SERVICE BULLETIN

Title: Chiller Pumpout Wiring Correction
Models Affected: All 06D Pumpout Units

Number: C9636
Date: 10/9/96

Correct Wiring

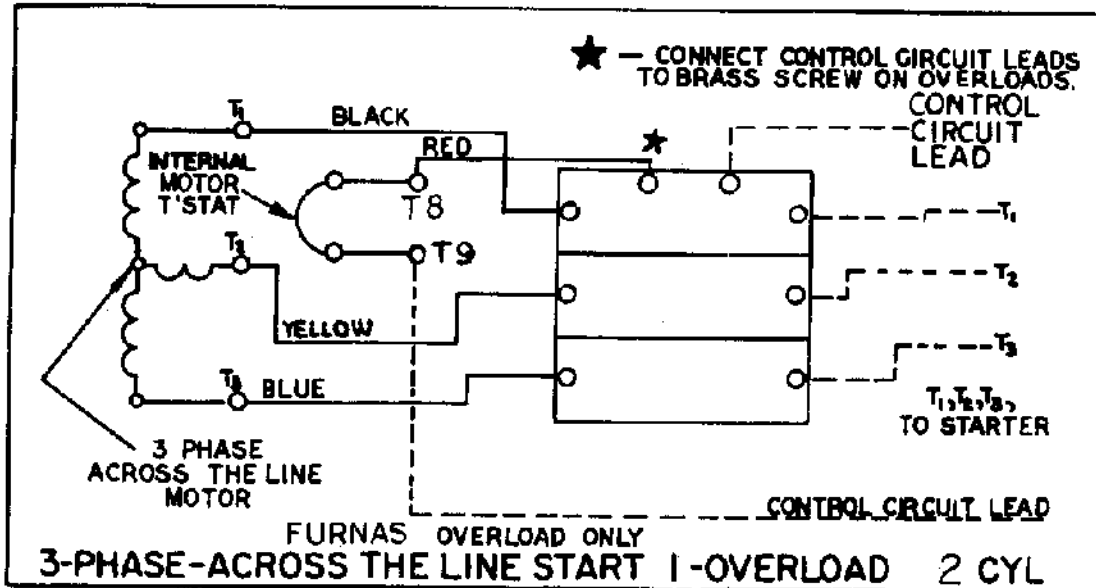
In the past, some pumpout compressors have been wired with the Control Circuit Lead connected directly to the "T8" Terminal. This by-passes the compressor overload protection. The Control Circuit Lead should be connected instead to the unoccupied overload terminal.

This bulletin provides wiring diagrams which show the correct and incorrect wiring. The diagram on the sticker inside the terminal box of the pumpout compressor is correct, and is identical to the diagram labeled "Correct Wiring". Some machines, however, have not been wired according to this diagram, but instead have been wired like the diagram labeled "Incorrect Wiring". The machines in question have a configuration with 2 overload terminals. Please verify that the overload wiring is correct in all machines with this configuration. Some older machines had an overload with 6 terminals instead of 2. In this case, it is not necessary to check the wiring.
